FOXCONN		HON HAI Precision Ind. Co., Ltd.	
Title		CCPBG - R&D Division	
Size		Document Number	
Custom		M9A0 MP	
Date:		Wednesday, October 28, 2009	Sheet 5 of 73
		Rev 1.1

FOXCONN		HON HAI Precision Ind. Co., Ltd.	
Title PCH (PCI-E, SMBUS, CLK)		CCPBG - R&D Division	
Size	Document Number	Rev	
Custom	M9A0 MP	1.1	
Date:	Friday, October 23, 2009	Sheet	10 of 73

FOXCONN		HON HAI Precision Ind. Co., Ltd.	
		CCPBG - R&D Division	
Title	VGA (PCI EXPRESS) 1 OF 9		
Size	Document Number	Rev	
Custom	M9A0 MP	1.1	
Date:	Thursday, November 19, 2009	Sheet	21 of 73

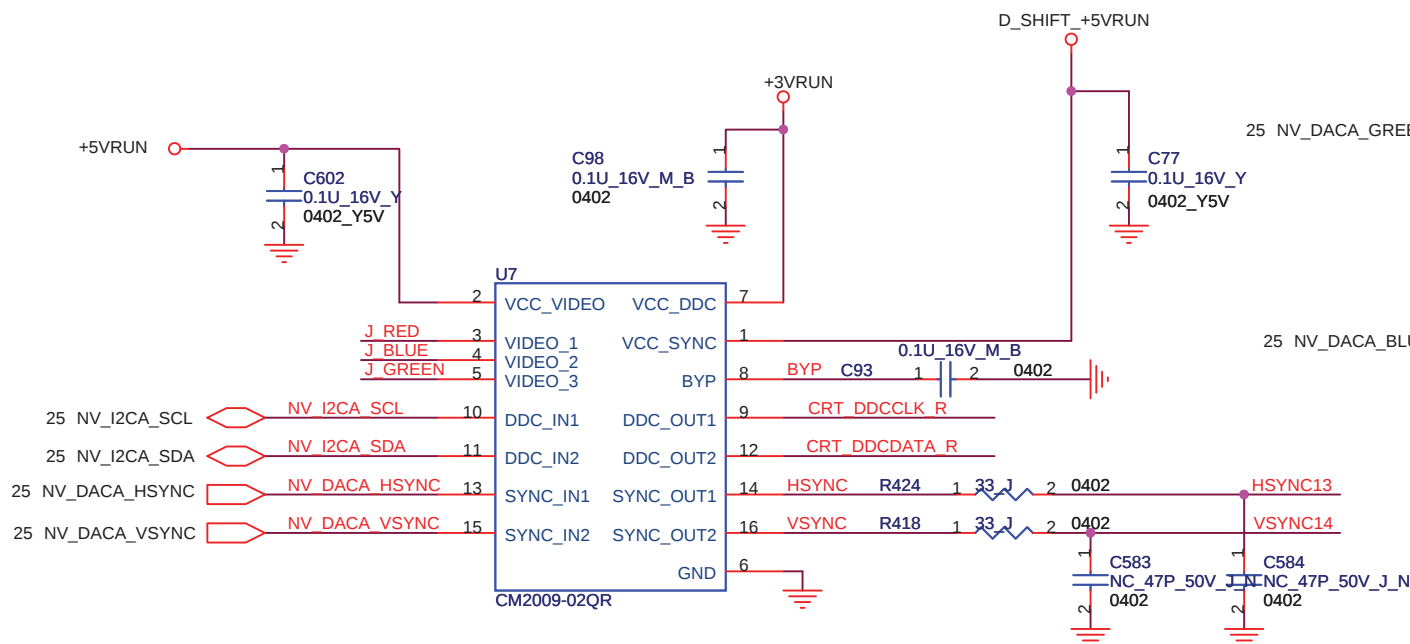
2009.11.03
Add C60,C62,C63,C64

2009.1104
Add C65,C66,C67,C73,C74 for FAN ISSUE

FOXCONN			HON HAI Precision Ind. Co., Ltd.		
Title EXPRESS CARD			CCPBG - R&D Division		
Size A3	Document Number M9A0_MP				Rev 1.1
Date:	Friday, October 23, 2009		Sheet	40	of 73

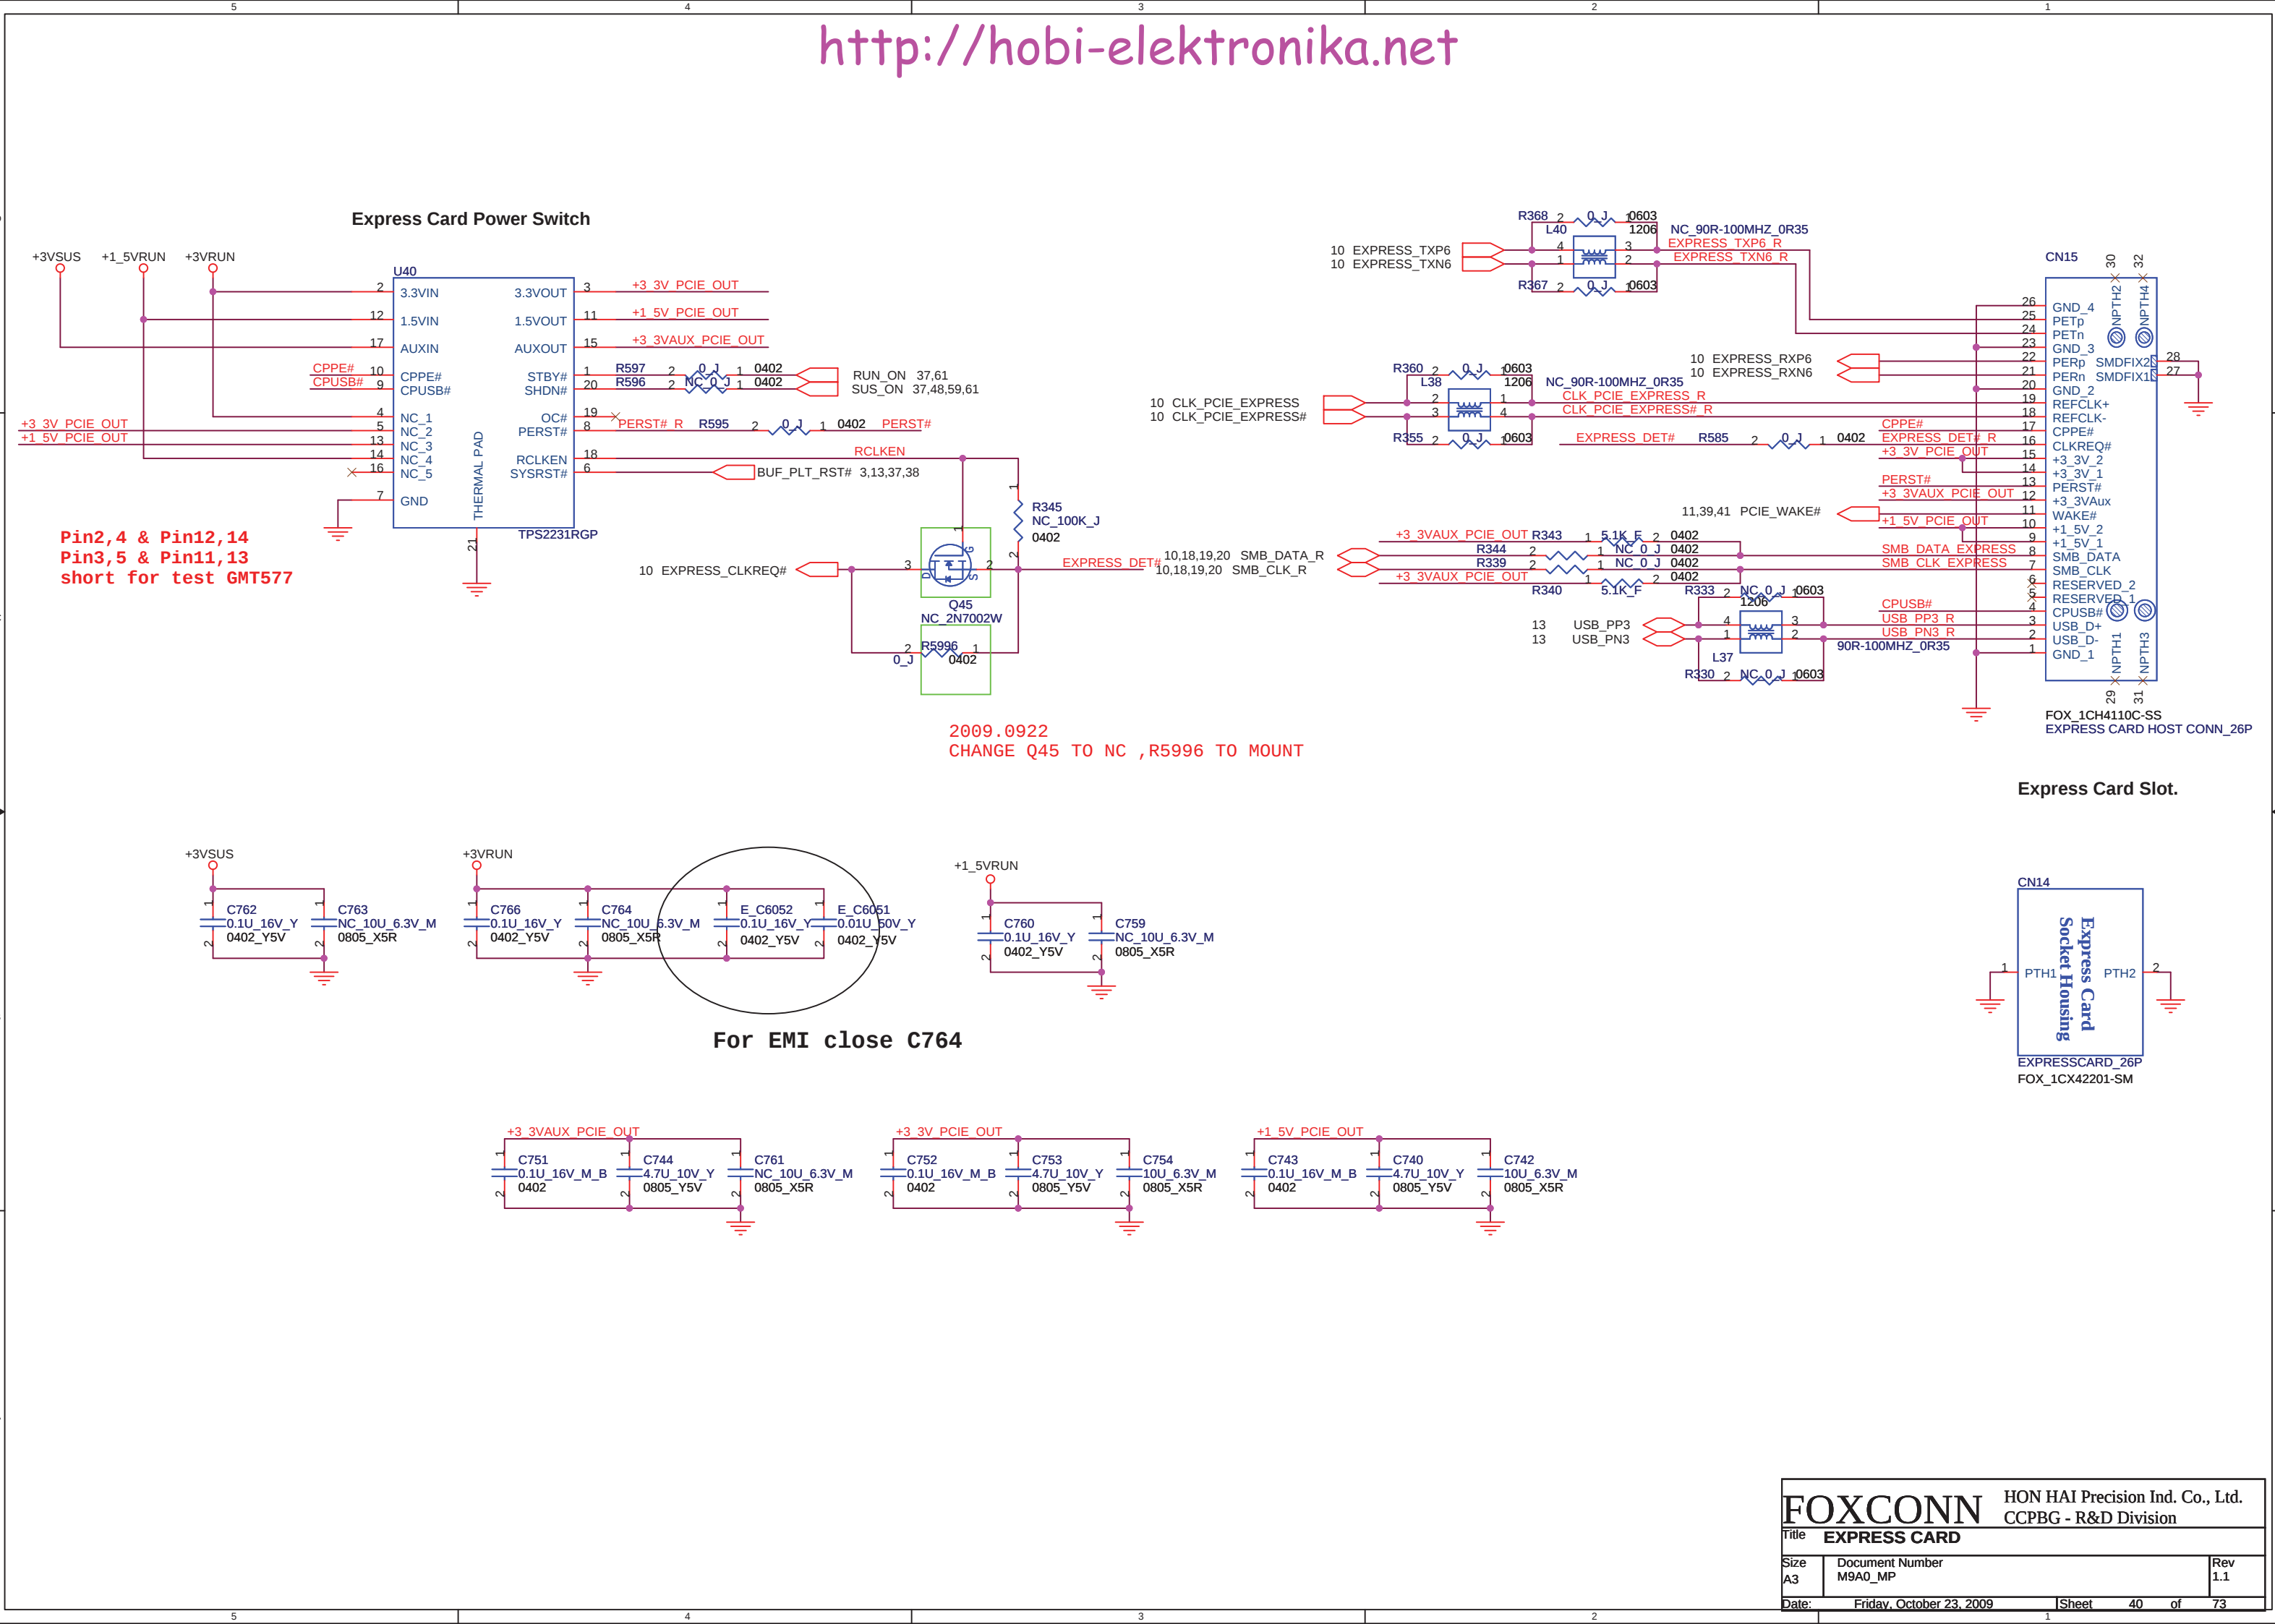
2009.0922
CHANGE Q45 TO NC ,R5996 TO MOUNT

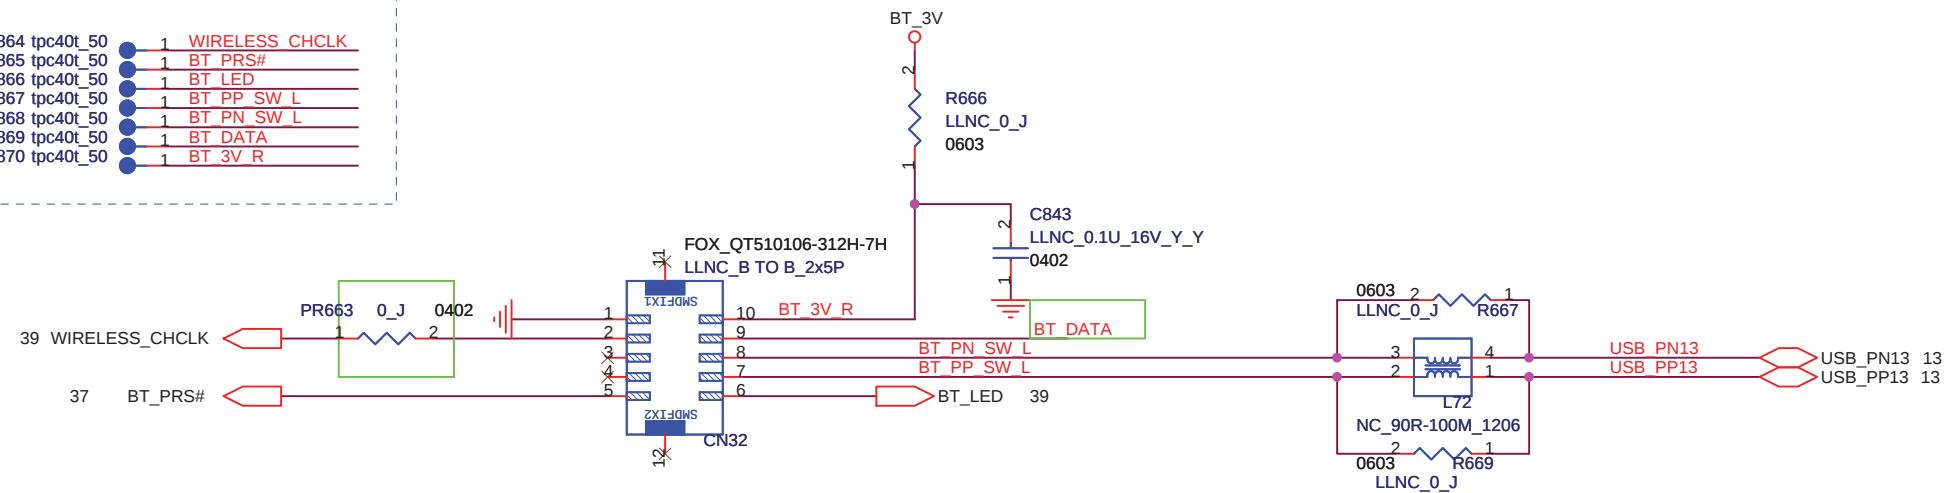
2009.11.19
Change R6009 from 1R-0000000-J200 to 1R-0000101-J200 for RF request

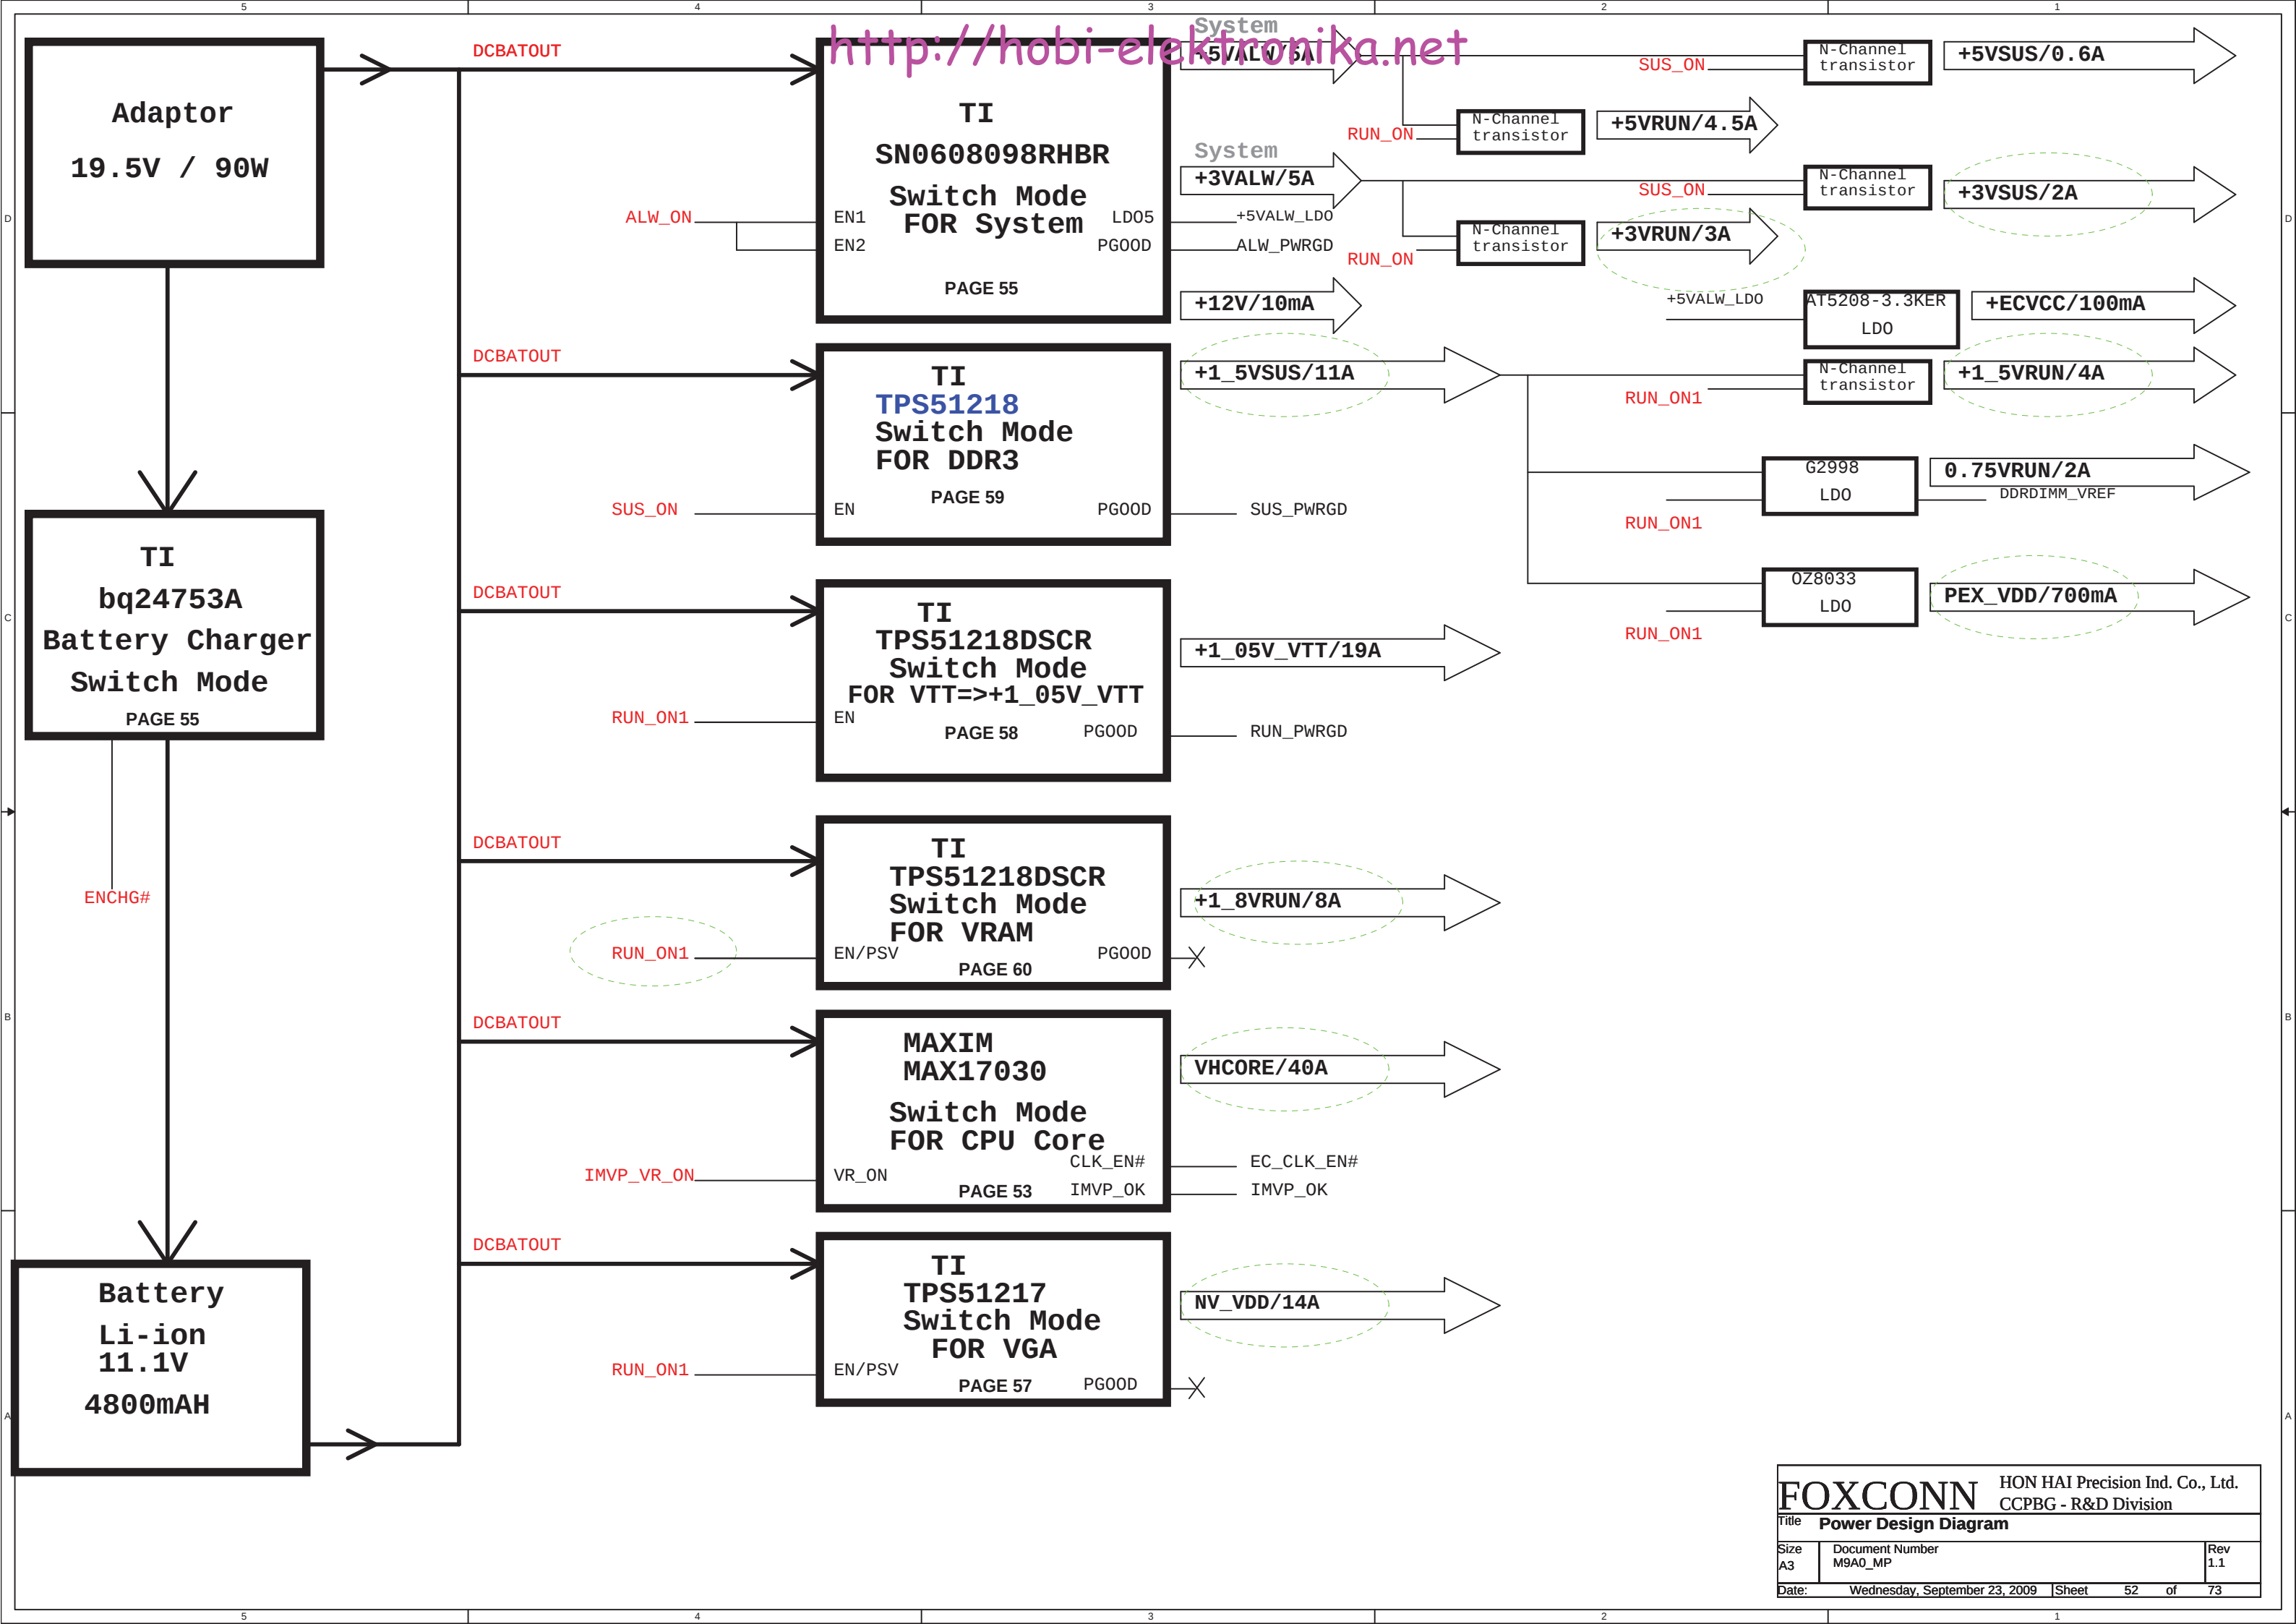
2009.10.30
change R5992,R5993,R5994 from 120ohm to 549ohm follow M870

2009.10.22
change PC112 from 68U to 47U for power request

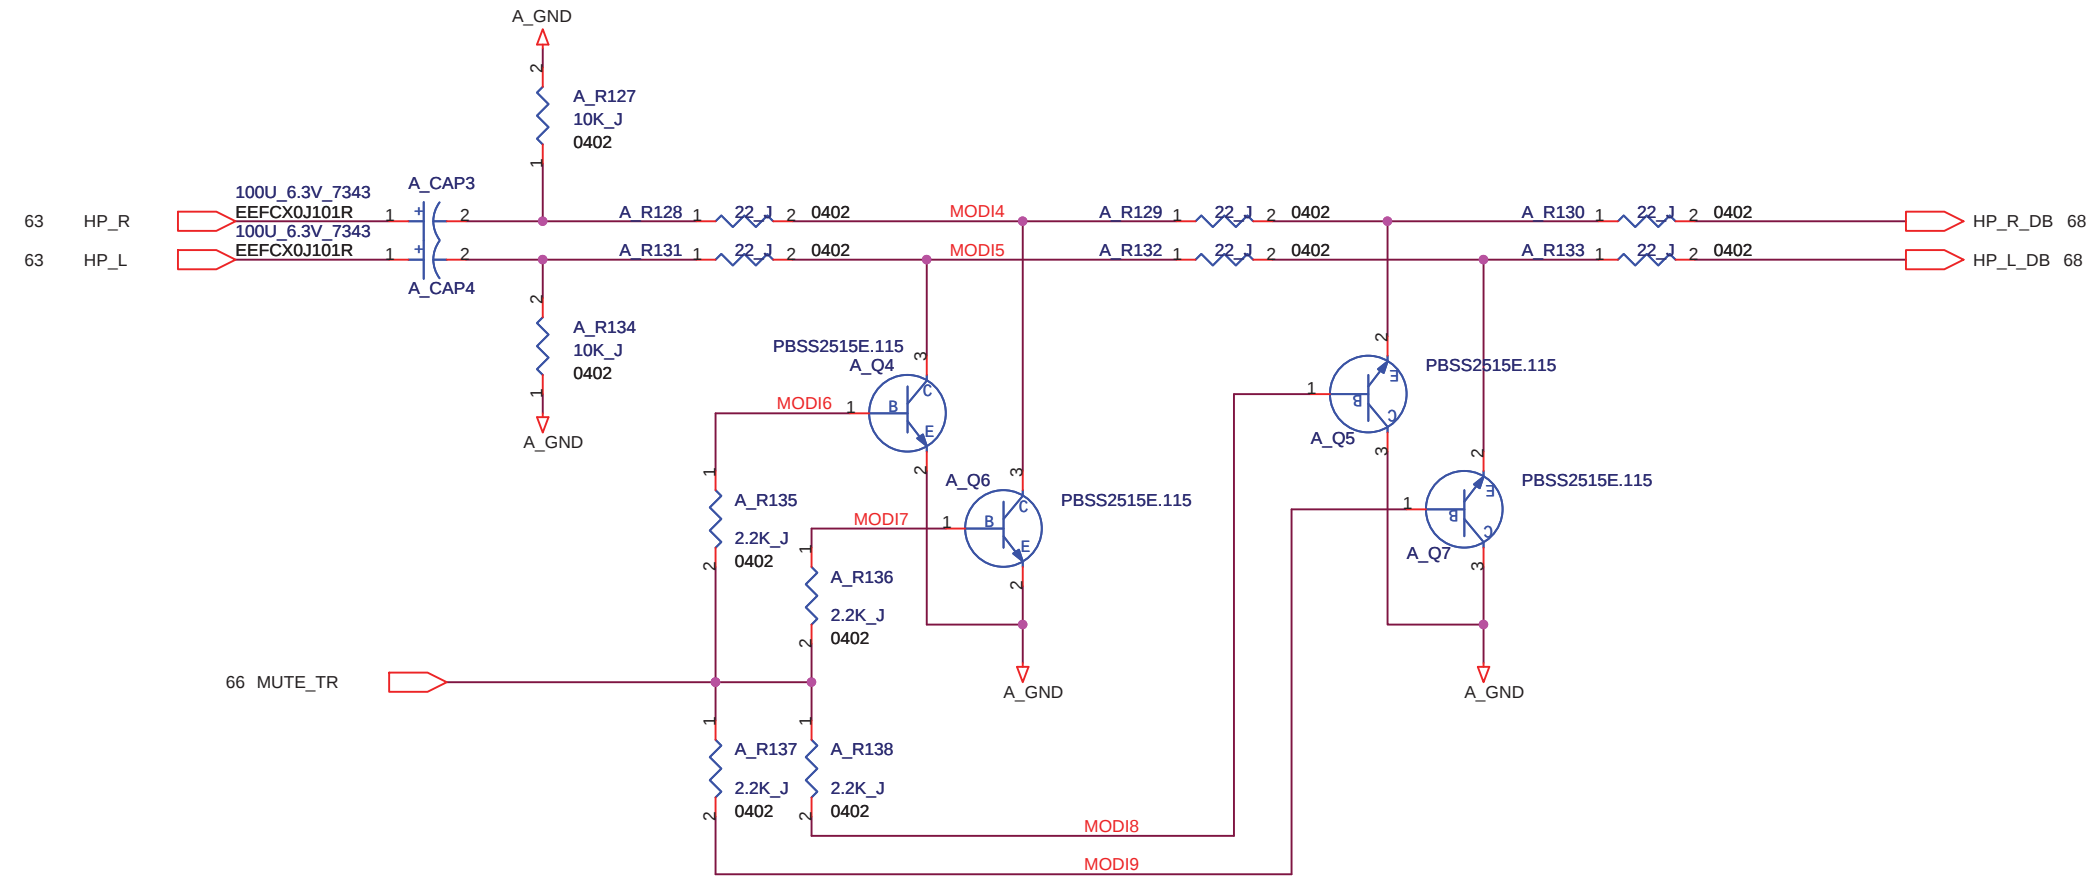
2009.11.03
change A_C23,A_C22 from 15PF to 22PF for EMI request
